82380AB (MISA) Docking PCIset

Specification Update

March 1999

Order Number: [297657-001](#)

1. DSPWRG must be synchronized.

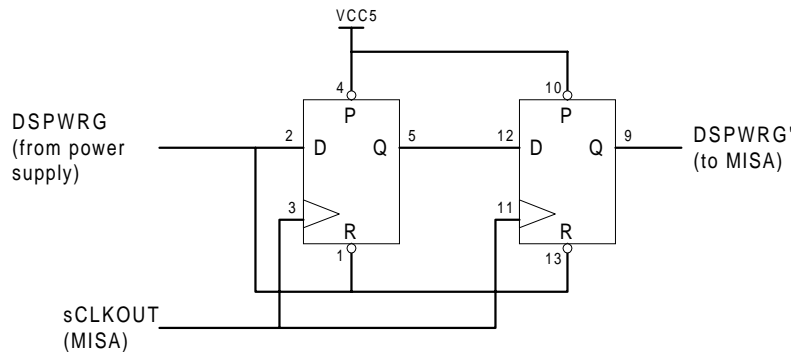
Problem: DSPWRG does not reset the device as expected if the PCICLK is not running when DSPWRG is asserted.

Implication: The MISA device will not function correctly.

Workaround: The following circuit will delay DSPWRG until PCICLK is running at MISA.
